Docket Number:	08-AFC-08A
Project Title:	Hydrogen Energy Center Application for Certification Amendment
TN #:	200387
Document Title:	Responses to PSA/DEIS Information Requests, Set 2
Description:	N/A
Filer:	URS
Organization:	URS Corporation
Submitter Role:	Applicant's Consultant
Submission Date:	9/3/2013 4:25:18 PM
Docketed Date:	9/3/2013

Responses to PSA/DEIS Information Requests, Set 2

Amended Application for Certification for HYDROGEN ENERGY CALIFORNIA (08-AFC-8A) Kern County, California

Figure BIO-7-1
Fox-Vehicle Collisions By Traffic Volume at Time of Death, Bakersfield, CA, 1998-2004

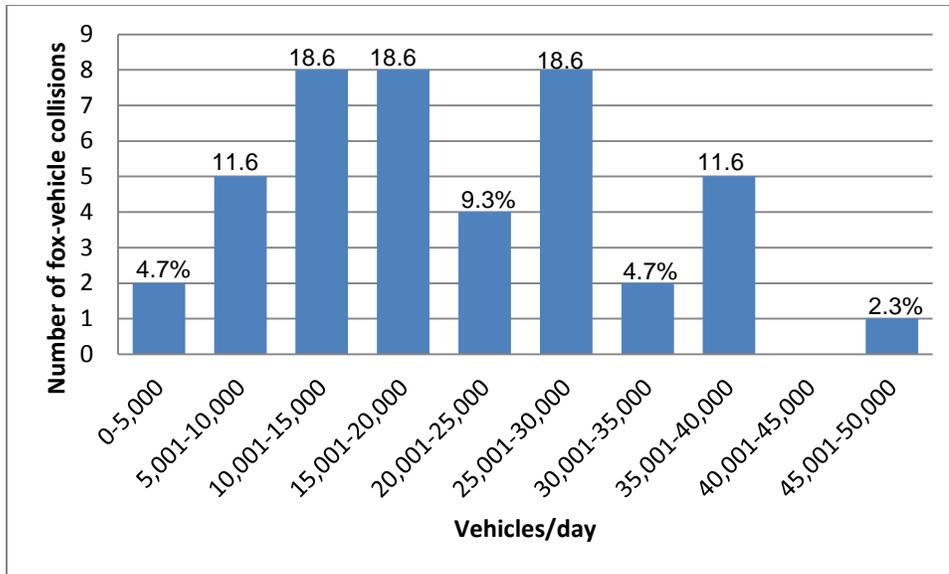
CEC Staff noted in the PSA/DEIS that the Waller probabilistic model, which looks only at traffic volumes and the time it takes an animal to cross the roadway, may be a more applicable method for determining wildlife incidental take due to roadkill. HECA's biological consultants have reviewed the Waller model and concluded that it is not the correct method to assess the potential impact to kit fox caused by Project-related vehicle activity. This conclusion is based on the inconsistencies between the Waller model and recent data collected on kit fox mortality in the Project area and vicinity. These inconsistencies are summarized below.

When the traffic volumes were examined by Bjurlin et al. (2005) for 43 of the vehicle-struck kit foxes, the mean traffic volume was 21,861 vehicles per day. The Waller model would expect mortality to increase as traffic volume increased; however, the distribution of these 43 vehicle-struck kit foxes shows a roughly bell curve distribution (see Figure BIO-7-1).

FIGURE BIO-8-1

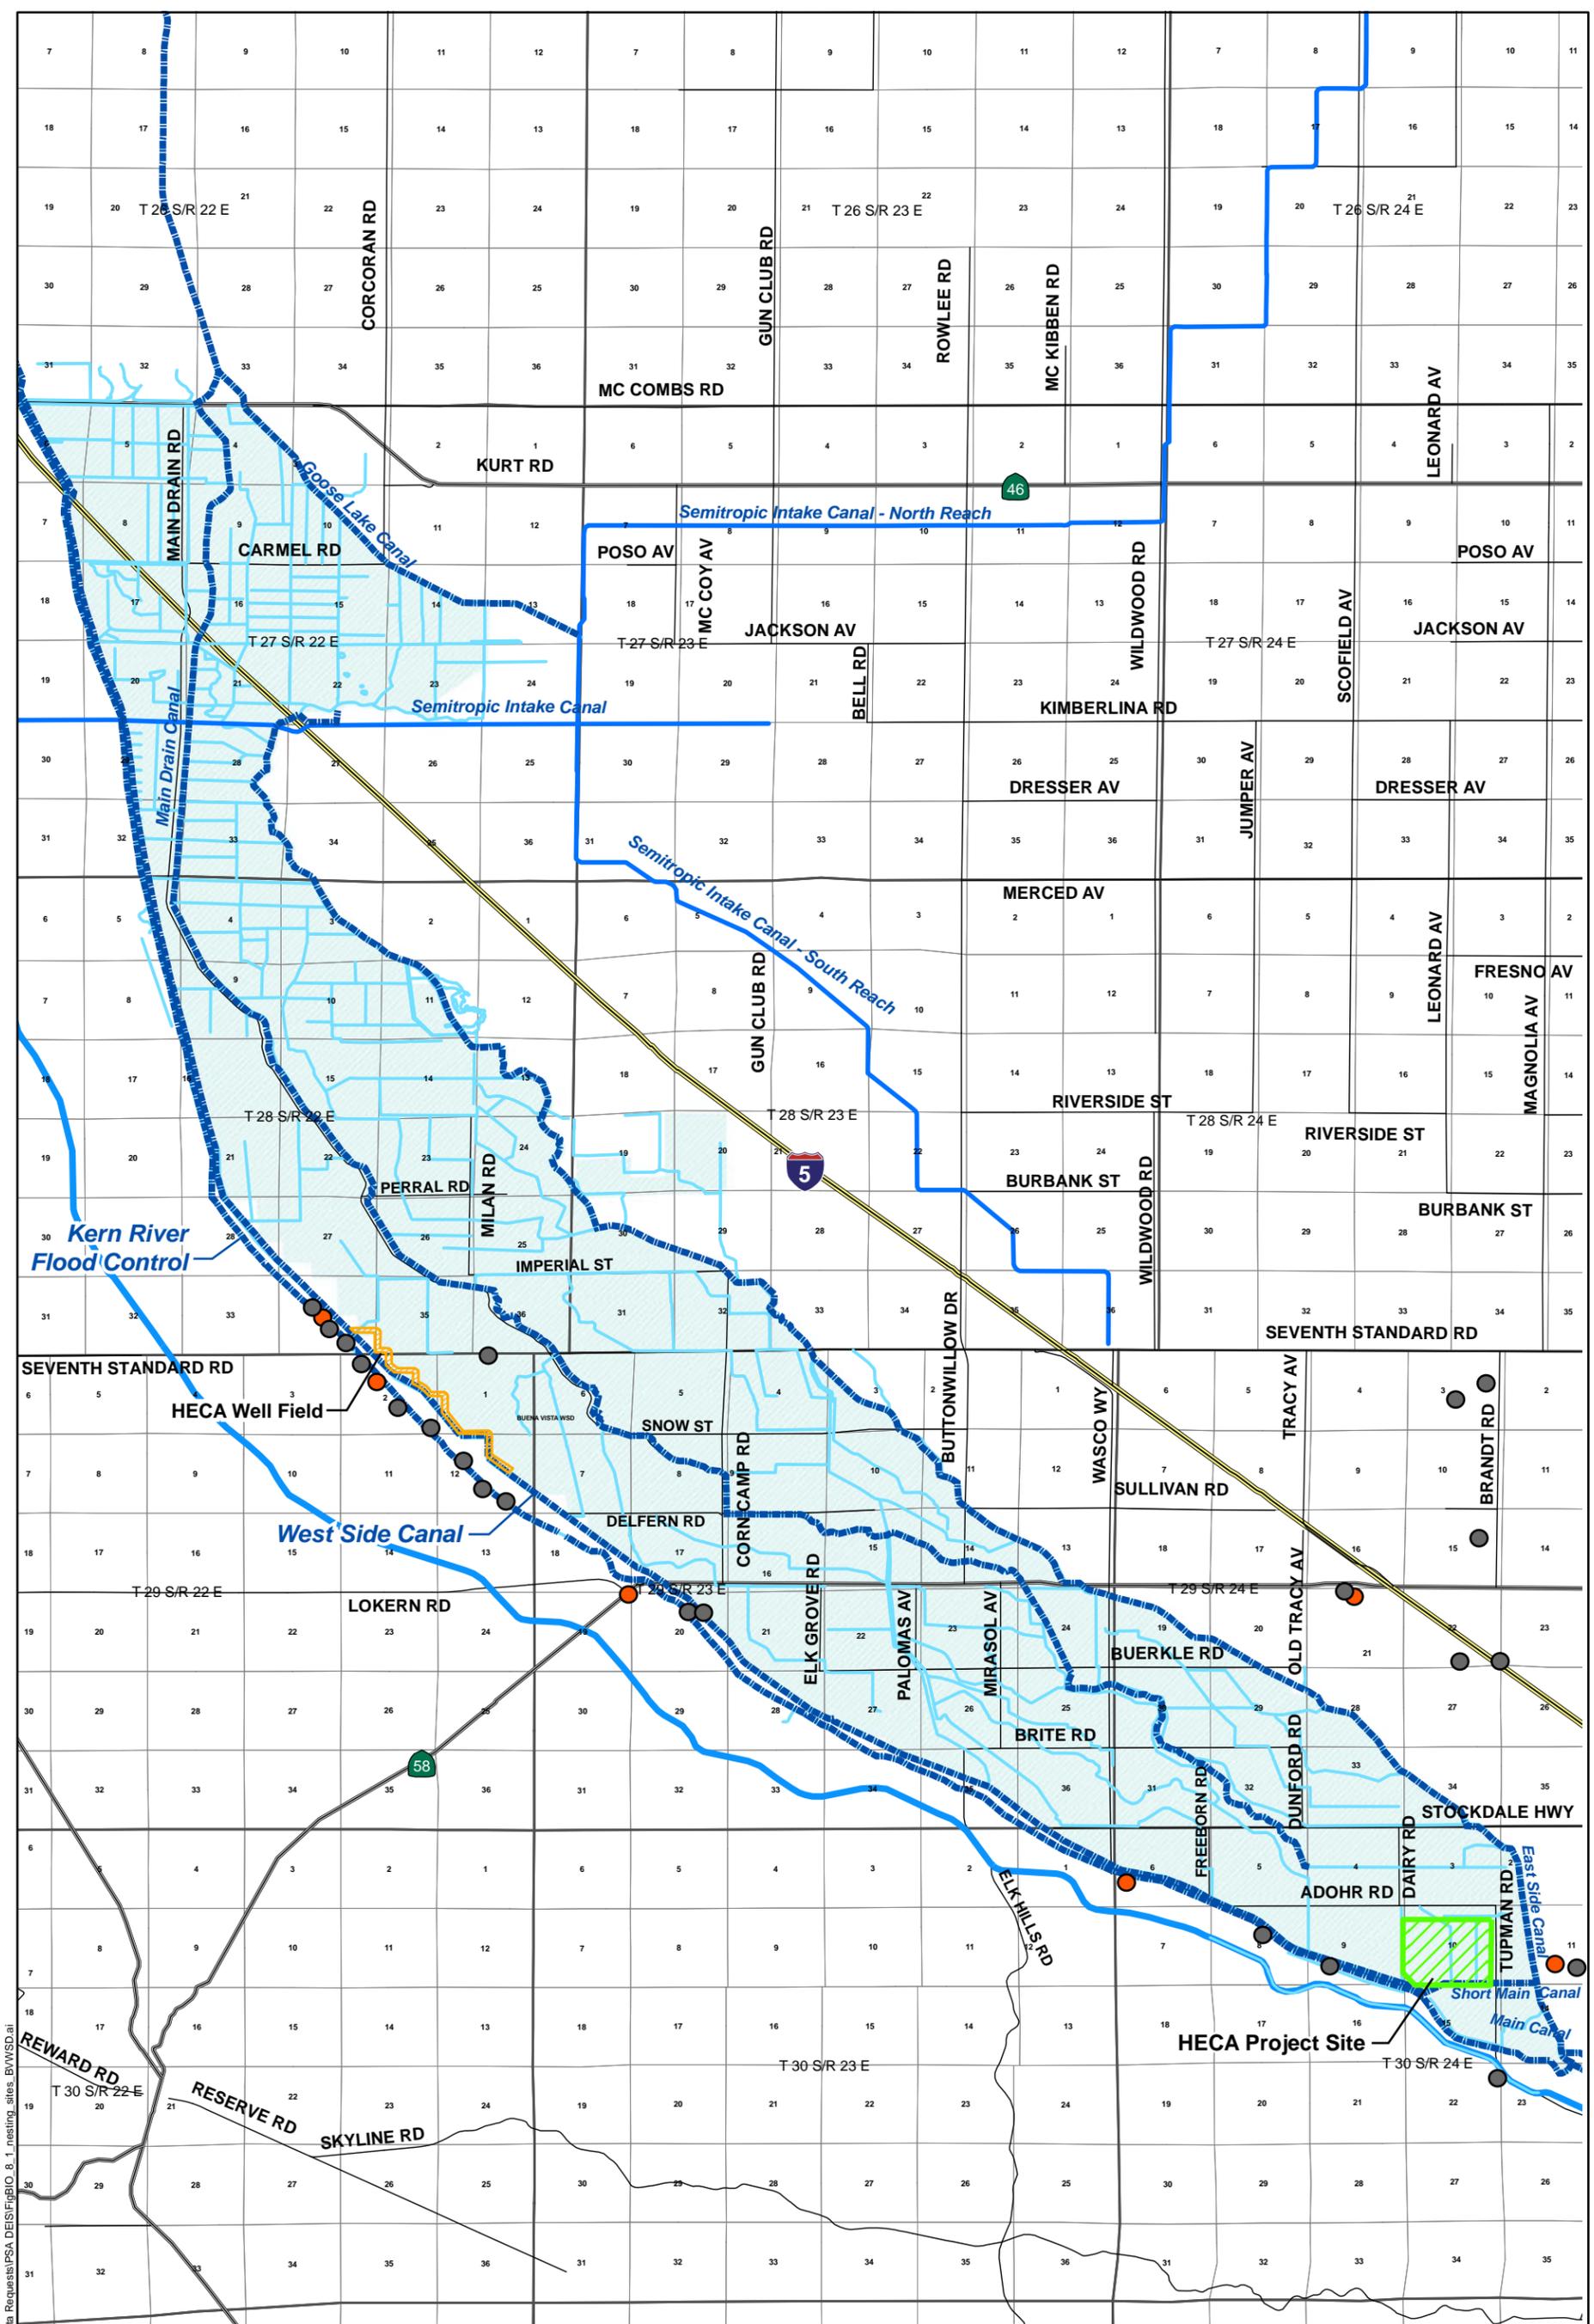
BIO-8. Water supply analysis and the effects of groundwater pumping to the sensitive vegetation communities and raptor nest trees which occur in the project area. The applicant must provide an analysis of the baseline groundwater levels and water source of raptor nest trees and alkali sink scrub habitat along HECA's linear routes, primarily the natural gas pipeline, processed water pipeline, and well field.

Figure BIO-8-1 identifies the locations of raptor nests (and other nest sites) documented in the Project area and vicinity, the planned location of the BGRP/HECA well field, and the various waterways within and adjacent to the BVWSD Buttonwillow Service Area (BSA). Nesting raptors, including Swainson's hawks, have been observed in the vicinity of the Project Area, in a tree near the center of the proposed BGRP/HECA well field. Swainson's hawk are listed as threatened under the California Endangered Species Act. Other nesting raptors and birds in the project area include common ravens and great-horned owls (see Figure 5.2-7 in the AFC).

As indicated on Figure BIO-8-1, the majority of the identified nesting sites are along the Kern River Flood Control Channel, immediately west of the western boundary of the BVWSD BSA. The West Side Canal is the western boundary of the BVWSD BSA and parallels the eastern margin of the Kern River Flood Control Channel. Localized recharge from seasonal flows in the Kern River Flood Control Channel are likely to be the main sources of water for the trees, but other sources may include infiltration from the West Side Canal, and irrigated fields.

As shown on Figure BIO-8-2, the 2011 average depth to groundwater (DTW) in the proposed BGRP/HECA well field area ranges from 40 to 70 feet below ground surface (bgs). Additional supporting data from the HECA Draft Hydrogeologic Data Acquisition Report (HDAR) (URS, 2010a) and the Draft HDAR Addendum (URS, 2010b) (December 2009 to March 2010 measured DTW from ten wells tested) indicate an average DTW of approximately 44 feet bgs (ranging from 36 to 53 feet bgs). Supplemental March 2012 DTW data from the BVWSD indicate that DTW ranges from approximately 30 feet bgs (in the north) to approximately 60 feet bgs (in the south) in the proposed BGRP/HECA well field area as water levels fluctuate in response to seasonal pumping/irrigation and recharge. Water levels also fluctuate with respect to water year.

FIGURE CS-7J-1

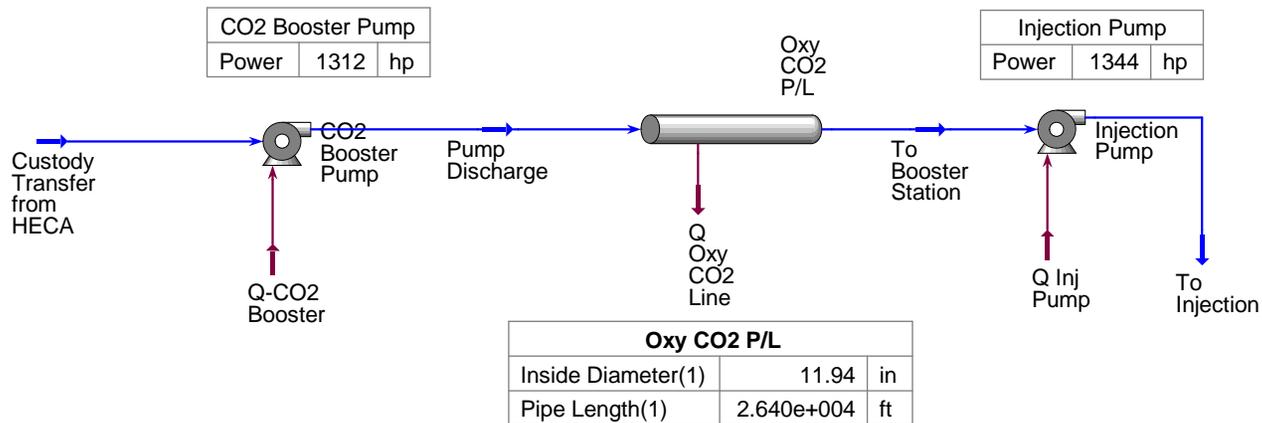
CS-7J. The applicant stated that the power consumption for initial CO₂ compression that is completed at the HECA site was sufficient to provide CO₂ at a pressure necessary for geologic sequestration.

- **Please confirm that means that the compression completed at the HECA site and the power consumed by the compressors on the HECA site is adequate to provide a level of compression that is sufficient to provide pressure necessary for geologic sequestration, or if the power consumption calculations include additional compression power consumption beyond that which is actually done at the HECA site that would be needed to obtain the desired pressure.**
- **Please indicate if the assumed pressure necessary for geologic sequestration is the same pressure that is required by Oxy Elk Hills (OEHL) to inject the CO₂ into the Stevens formation.**
- **Please indicate how much pressure is lost in terms of equivalent power consumption from the CO₂ custody transfer point to the point of receipt at the OEHL central EOR facility for initial injection into the oil reservoir.**

The HECA CO₂ compressor pressurizes the CO₂ to approximately 2,500 pounds per square inch gauge (psig). At the HECA plant boundary, OEHL pressurizes the CO₂ stream to approximately 3,300 psig, consuming approximately 1,300 horsepower (hp) (or 975 kilowatts [kW]). The stream is transported by pipeline roughly 5 miles to the booster station; it loses approximately 270 psig pressure through the pipeline due to frictional losses. At the booster station, the CO₂ stream is pressurized to approximately 4,000 psig for injection into the Stevens reservoir for EOR and resulting sequestration, consuming approximately 1,360 hp (1,020 kW). Please see Figure CS-7J-1 for details.

FIGURE WS-6-1

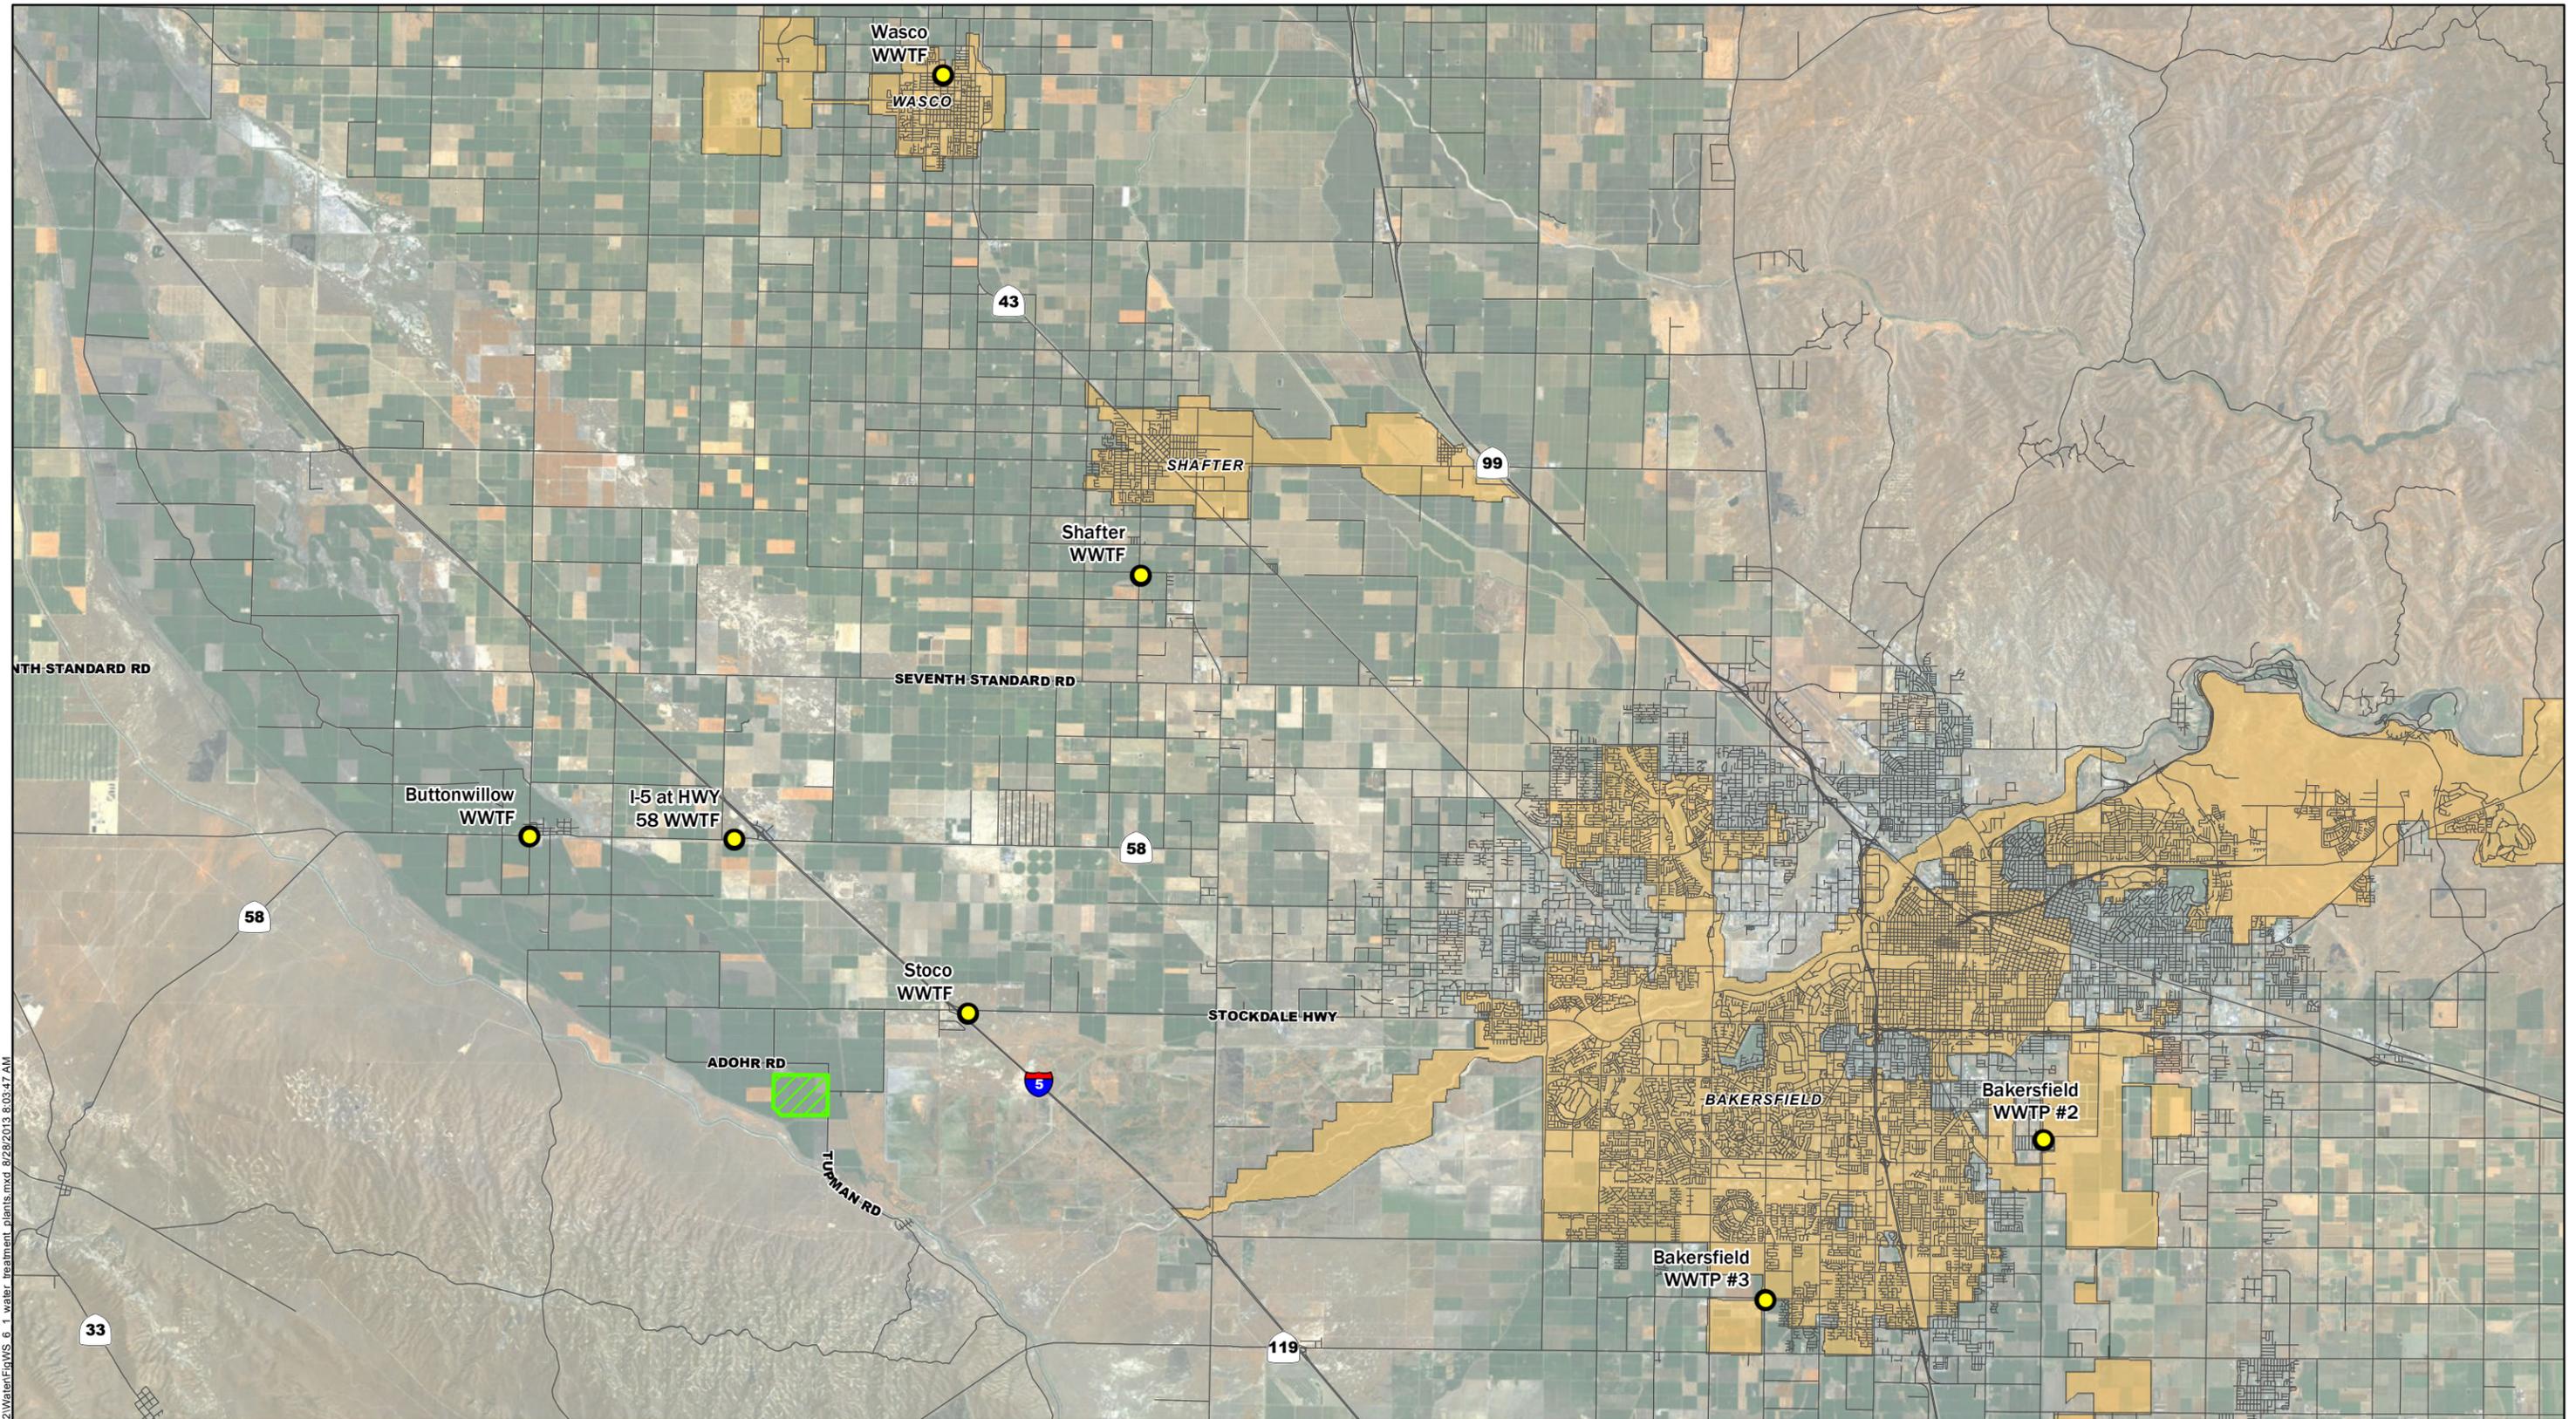
WS-6. Water alternatives dismissed by the applicant such as municipal wastewater from Bakersfield, oil field wastewater, or BVWSD Target Area A water, were eliminated because they can't supply the proposed project's entire water supply. However it is unreasonable to dismiss all of these options when any one of them could provide up to 50 percent of the project's water needs.

The Applicant reviewed information for wastewater treatment plants (WWTPs) within 25 miles of the Project site (see Figure W-6-1). Five facilities are very small and handle less than 2 mgd of sanitary wastewater. Only two facilities, Bakersfield WWTP #3 and Bakersfield WWTP #2, handle sufficiently large volumes of sanitary wastewater flows. There is no tertiary-treated water (i.e., recycled water) currently available from the local municipal WWTPs.

The Project Site is approximately 17 miles northwest of the City of Bakersfield WWTP #3 (see Figure WS-6-1). This plant treats the municipal effluent generated from the western portion of the City of Bakersfield (i.e., generally west of Highway 99). The plant was upgraded in 2010, and has a current treatment design capacity of 32 mgd, although the average amount of wastewater currently handled is approximately 16 mgd. The plant's upgrades included improvements to the primary and secondary treatment systems, as well as a 2-mgd tertiary treatment facility to produce recycled water for use on nearby landscaping and at the WWTP. All of the 2 mgd of recycled water is currently used for landscaping, and there is no excess available for the HECA Project (CVRWQCB, 2009a).

Other WWTPs in Kern County are much smaller than Bakersfield’s WWTP #3 and #2, and are not able to provide the necessary quantity of water to the HECA Project. Also, none of these plants produce tertiary-treated water. Figure WS-6-1 shows the location of the WWTPs in the vicinity of the HECA Project. A summary of the plants and their associated design capacities is provided in Table WS-6-1.
